HPK/2022/0412

Meadowbank, Whitehough, Parking Space

As proposed

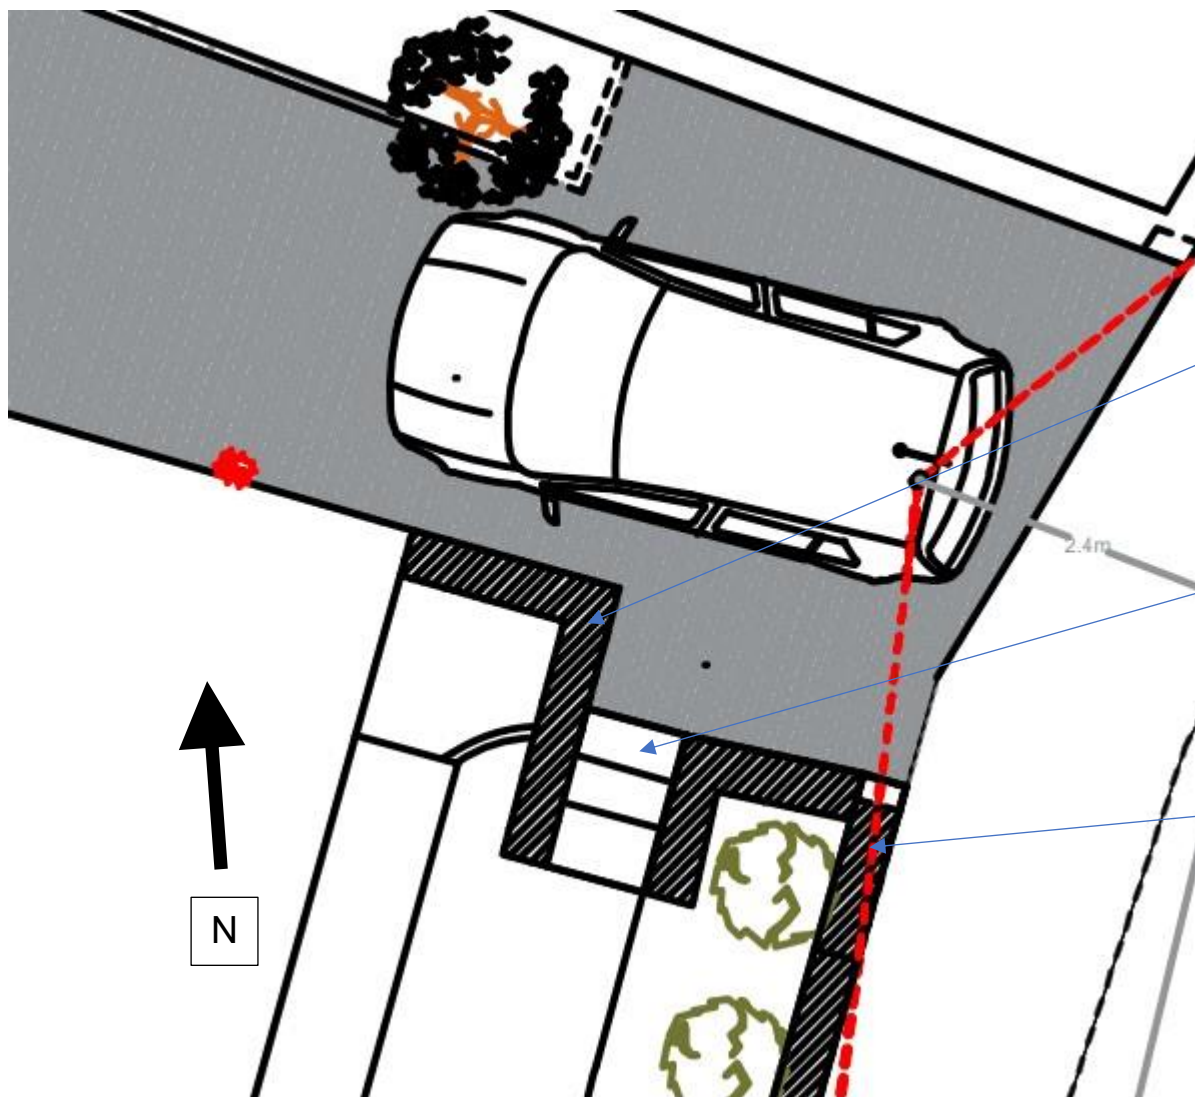
This portion of vulgar stone wall is already approved for removal

Revised elevation shows an additional 750mm of dressed stone removed to improve access coupled with a realignment of the garden steps as indicated in the DCC Highways sightline plan already submitted to HPBC Planning.

Revised Elevation: 1 metre of coping lowered to 900mm height to improve the south sightline.
(As discussed with Derbyshire CC Highways)

Proposed dropped kerb to be extended 750mm southwards

Existing “DIY” rough stone wall to be replaced with dressed stone identical to main house.

Garden steps relocated 750mm southwards

Additional 750mm of dressed stone to be removed and material used to build retaining walls for garden steps

First metre of revised boundary wall to be lowered from 1150 mm to 900mm to achieve highway sightline.
